**Committee of Experts on the Transport of Dangerous Goods  
and on the Globally Harmonized System of Classification  
and Labelling of Chemicals**

**Manual of Tests and Criteria, update test Series H:  
determination of self-accelerating decomposition  
temperature**

**Transmitted by the Chairman of the Working Group on Explosives**

5. The outcome of the discussions and consequent proposed amendments to the **7<sup>th</sup> revised edition of the manual of tests and criteria** are given in this document. All changes are indicated; inserted text is shown **red** and deleted text in **red, strikethrough**.

Figure 28.4.2.1: Adiabatic storage test

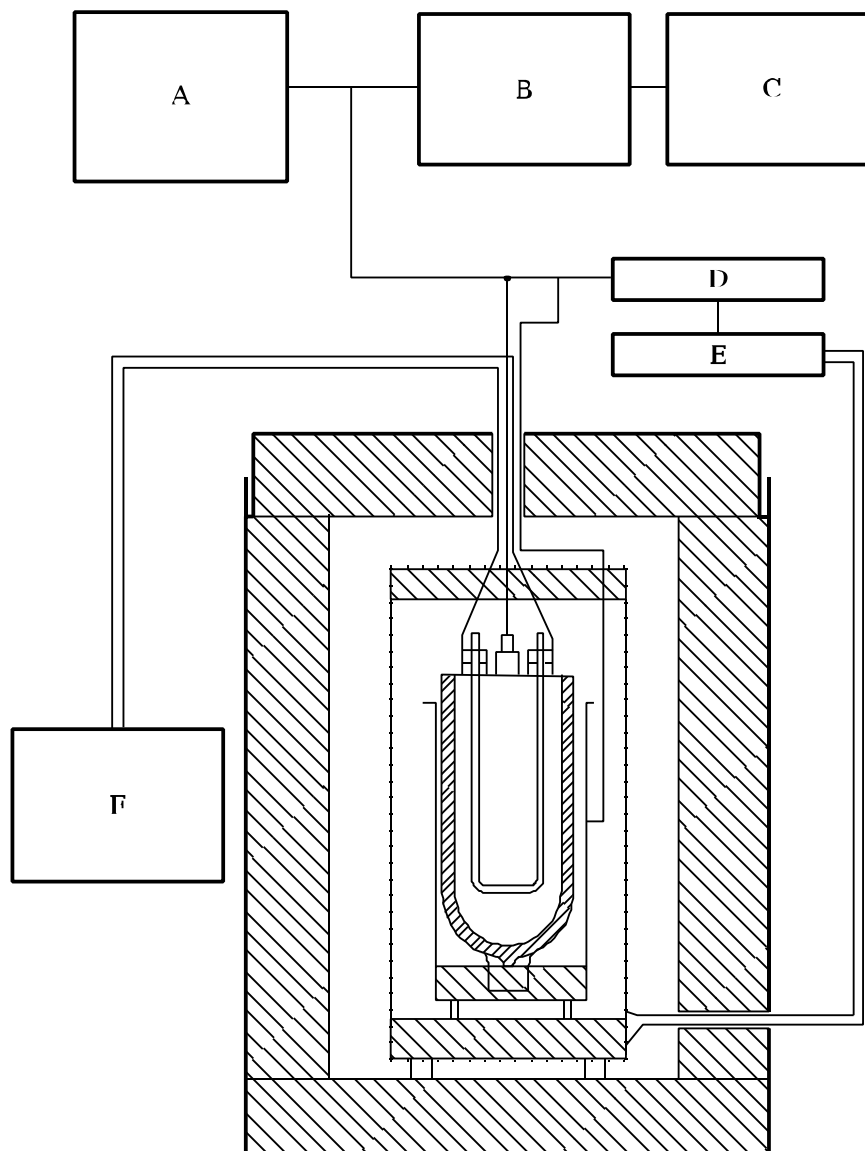
The apparatus consists of a glass Dewar vessel (~~max. 31.0 or 1.5~~ litre) to contain the sample, an insulated oven with a differential control system to keep the temperature in the oven to within 0.1 °C of the sample temperature, and an inert lid for the Dewar vessel. In special cases, sample holders of other construction materials may have to be used. An inert heating coil and cooling tube pass through the lid into the sample. Pressure build-up in the Dewar vessel is prevented by ~~a 2-m-long PTFE~~ sufficiently long capillary tube ~~made of an inert substance (e.g. 2 m long PTFE tube) which passes~~ through the insulated lid. A constant power heating unit is used for internal heating of the substance to a ~~pre-set~~ preset temperature or for calibration. Internal heating and cooling may be stopped or started automatically at ~~pre-set~~ preset temperatures. In addition to the cooling system, a secondary safety device is ~~used to fitted which~~ disconnects the power supply to the

oven at a ~~pre-set~~ preset temperature. A schematic drawing of ~~the~~ an open apparatus for the adiabatic storage test ~~AST~~ is given in Figure 28.4.2.1.

Figure 28.4.3.1: Measuring period as a function of maximum heat generation measured

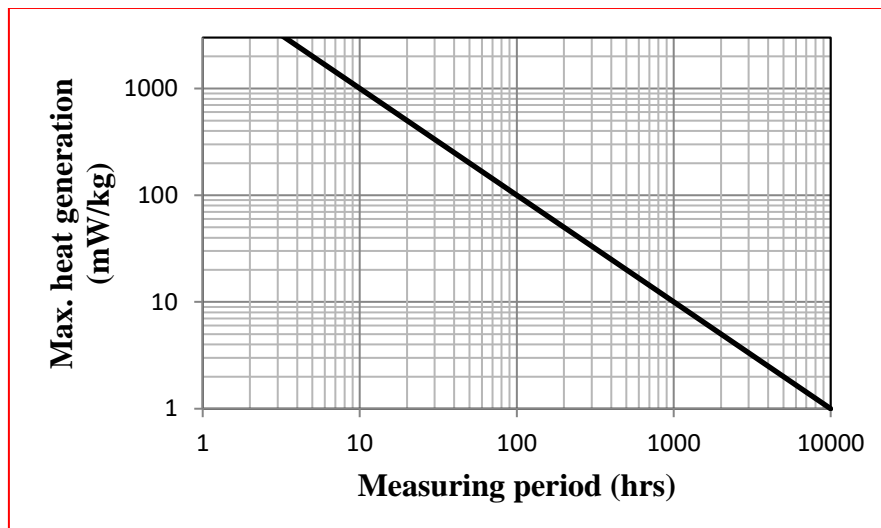
The measuring time as given in Figure 28.4.3.1 can be used as guidance unless it leads to unrealistic measuring times (e.g. greater than 1000 hours). These measuring times are

given to achieve a certain degree of conversion of the substance in order to take auto-catalytic effects into account;<sup>1,2</sup>

Figure 28.4.4.1: Dewar vessel with closure for testing liquids and wetted solids

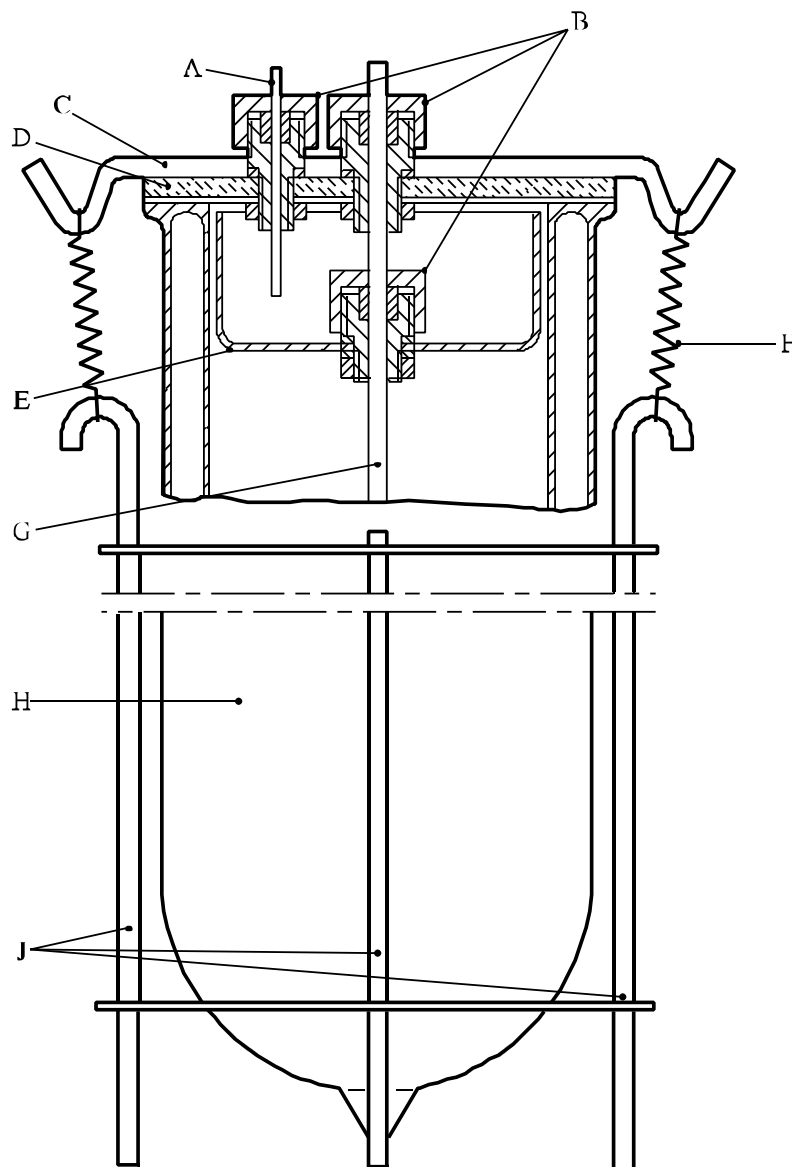
28.4.4.2.6 Dewar vessels, with their closure system, are used with heat loss characteristics which are representative of the maximum ~~size-of~~ package size under investigation (see also table 28.4) ~~offered for transport~~. The closure of the Dewar vessel should be made of inert material. Particularly for solids, cork or rubber bungs may be used. An example of a closure system for use with liquids with low or medium volatility

**and wetted solids** is illustrated in Figure 28.4.4.1. Samples which are highly volatile at the test temperature should be tested in a pressure-tight ~~metal~~ vessel **that is made of a material compatible with the sample and** fitted with a pressure relief valve. The pressure vessel is placed in the Dewar vessel and the effect of the heat capacity of the metal vessel taken into account by calculation.
